Re: Thorndike Place, Arlington (MassHousing ID #778/#779)
Notice of Project Revision Under 760 CMR 56.04(5)

THORNDIKE PLACE COMPREHENSIVE PERMIT DOROTHY ROAD ARLINGTON, MASSACHUSETTS

REVISED: NOVEMBER 3, 2020

OVERALL SITE PLAN

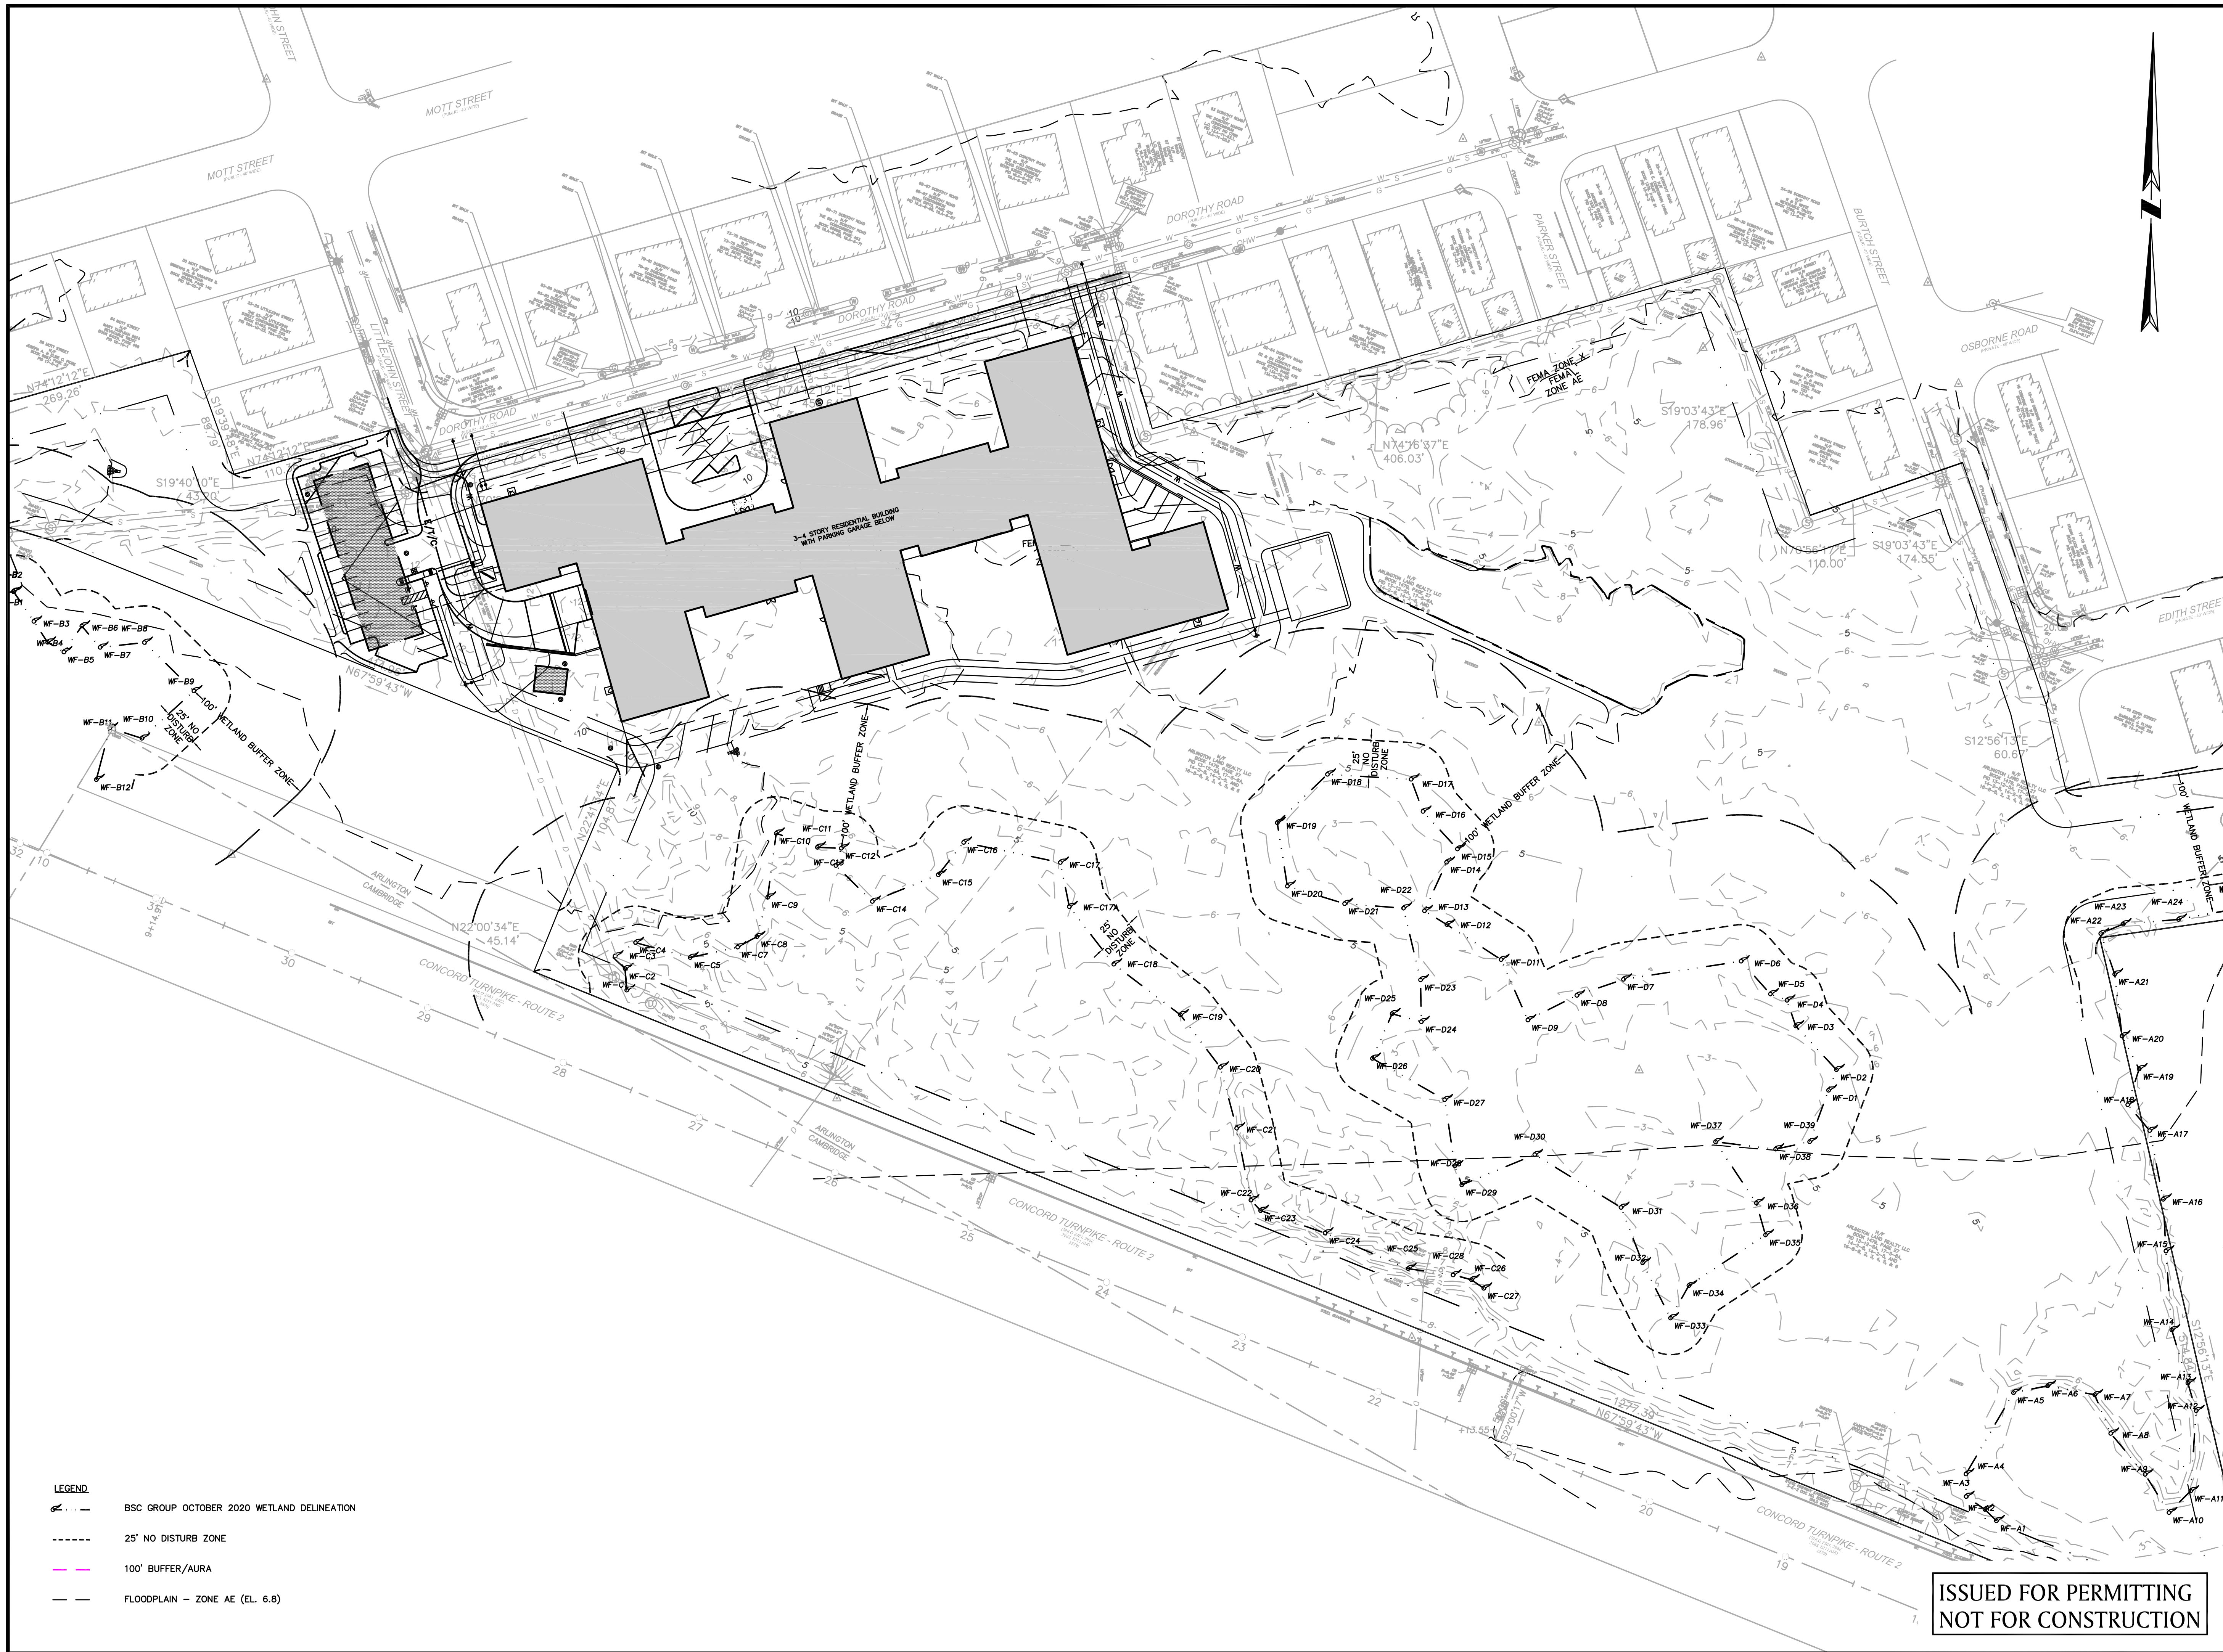
REVISIONS:		
NO.	DATE	DESC.
1	9/18/20	NEW BUILDING FOOTPRINT
2	10/22/20	WETLAND DELINEATION
3	11/03/20	REVISED BUILDING

GRADING &
DRAINAGE PLAN

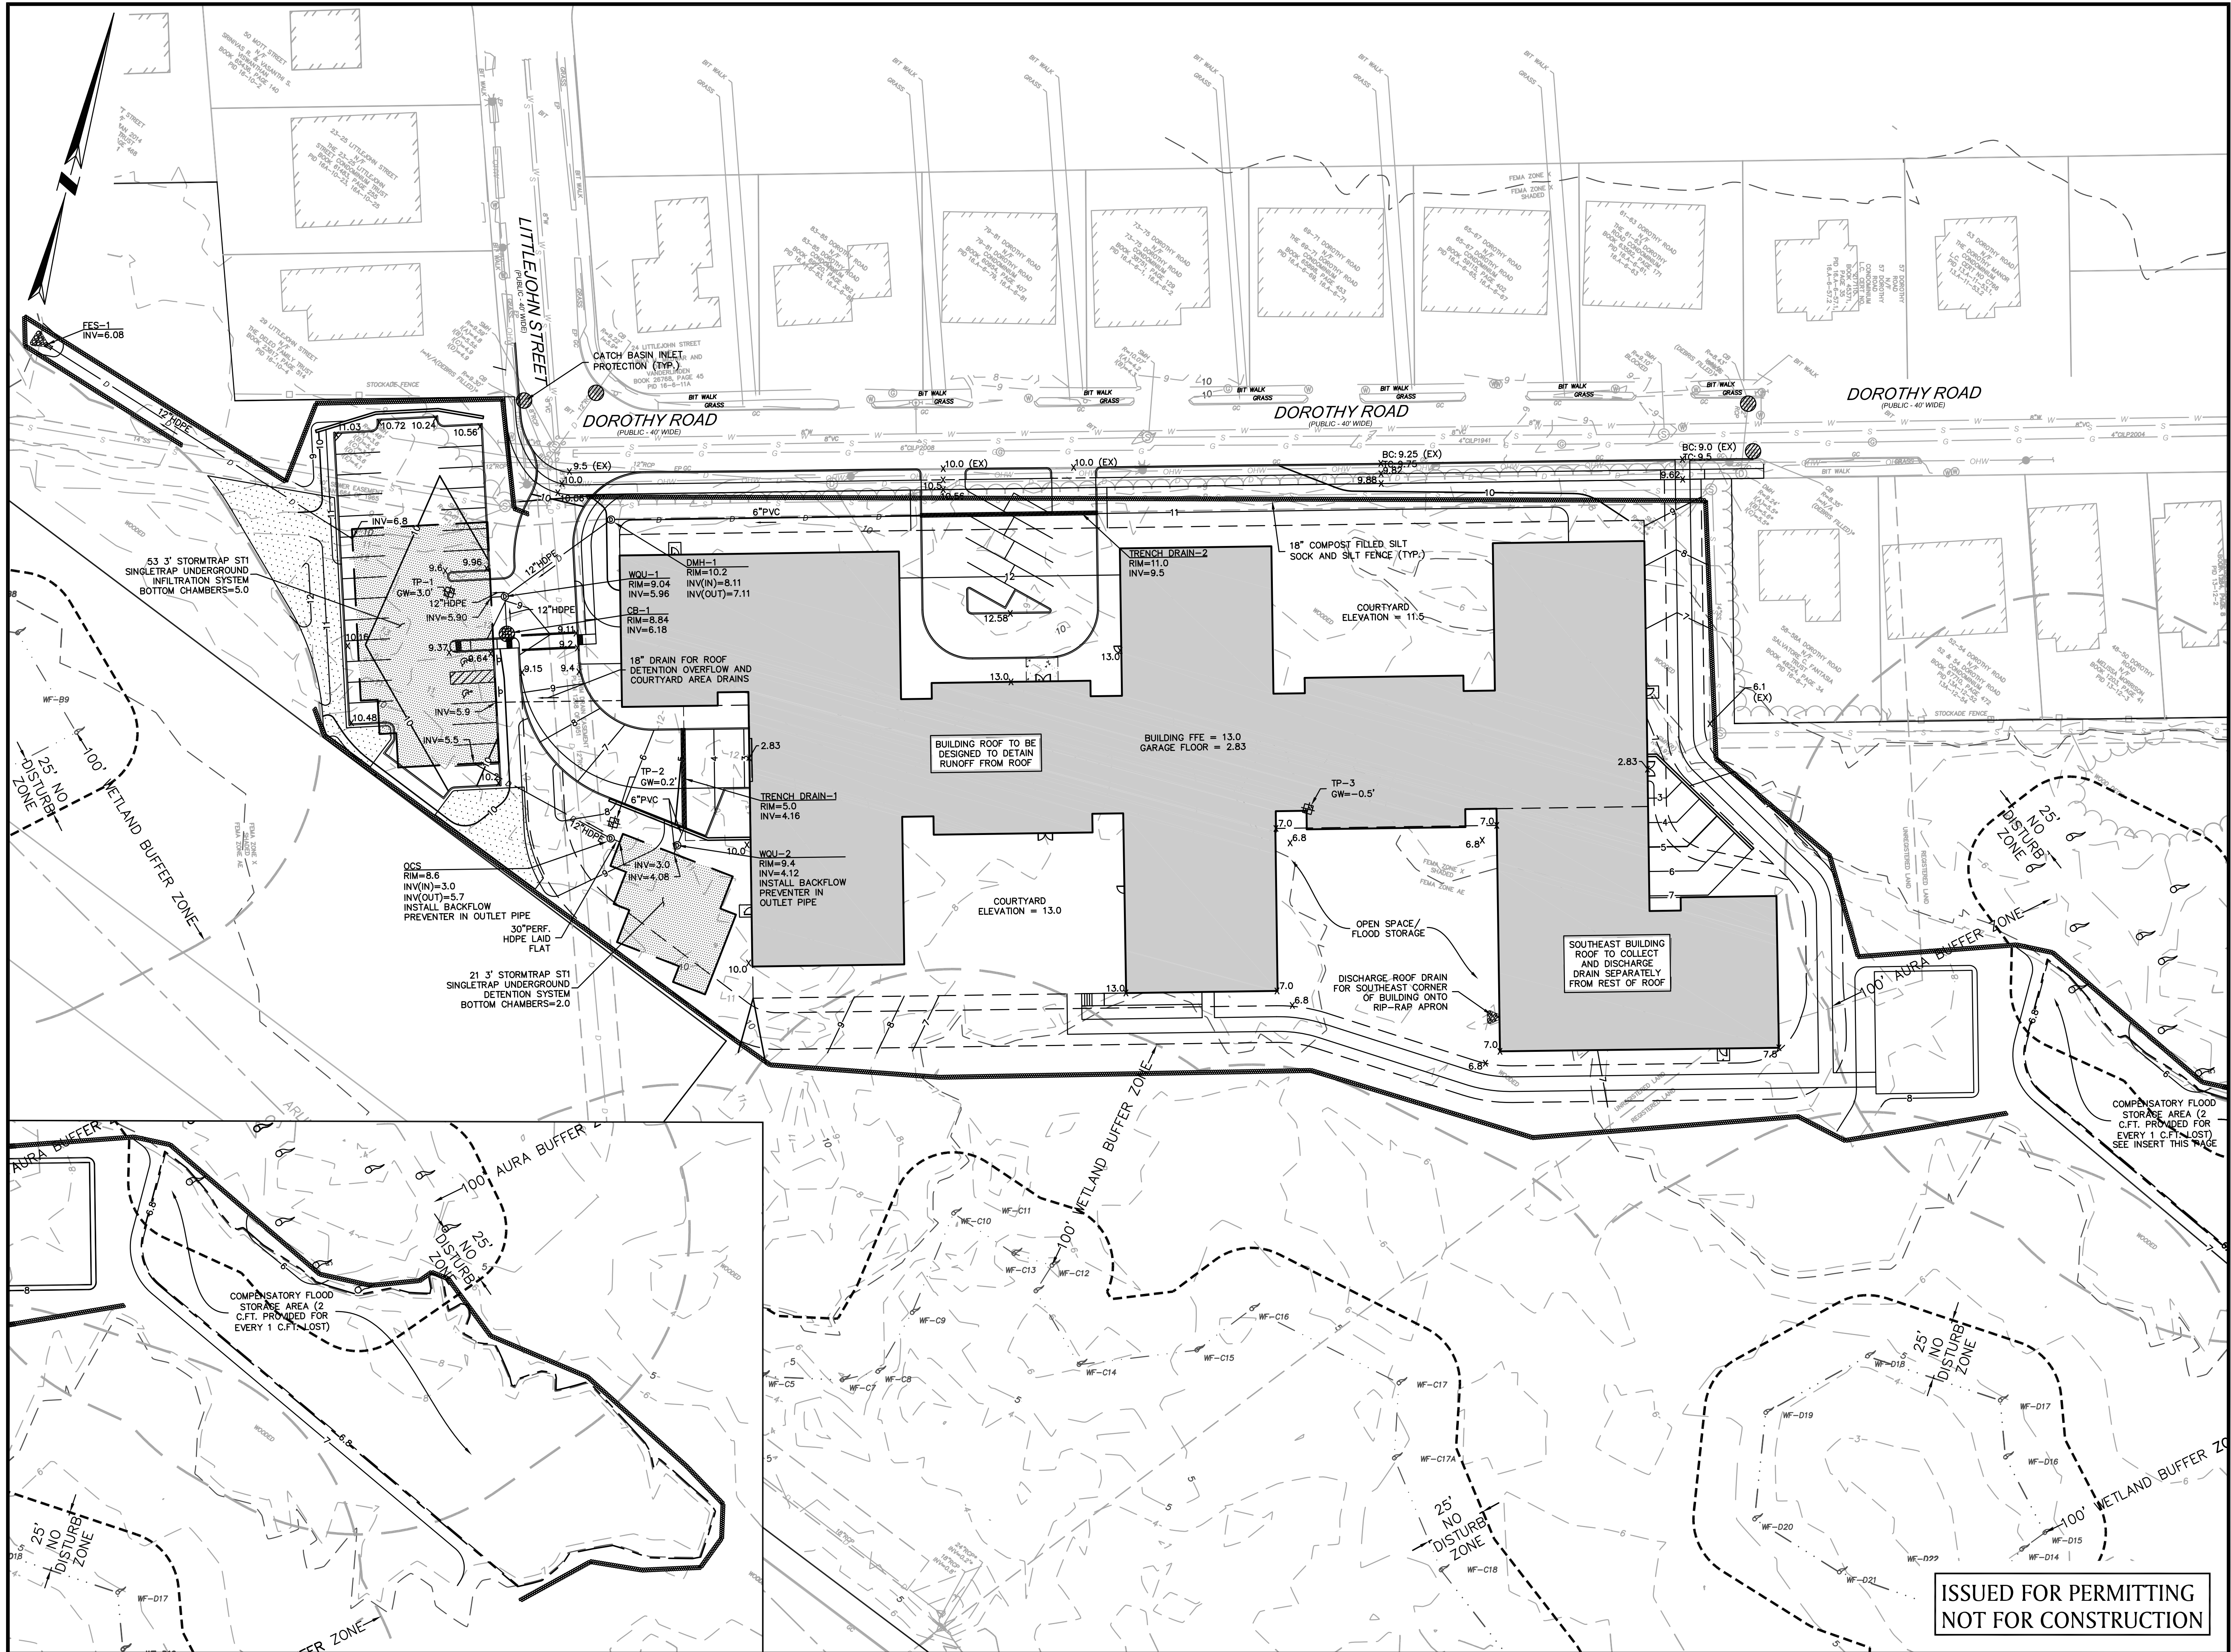
REVISIONS:		
NO.	DATE	DESC.
1	9/18/20	NEW BUILDING FOOTPRINT
2	10/22/20	WETLAND DELINEATION
3	11/03/20	REVISED BUILDING
4	01/21/21	RESPONSE TO PEER REVIEW
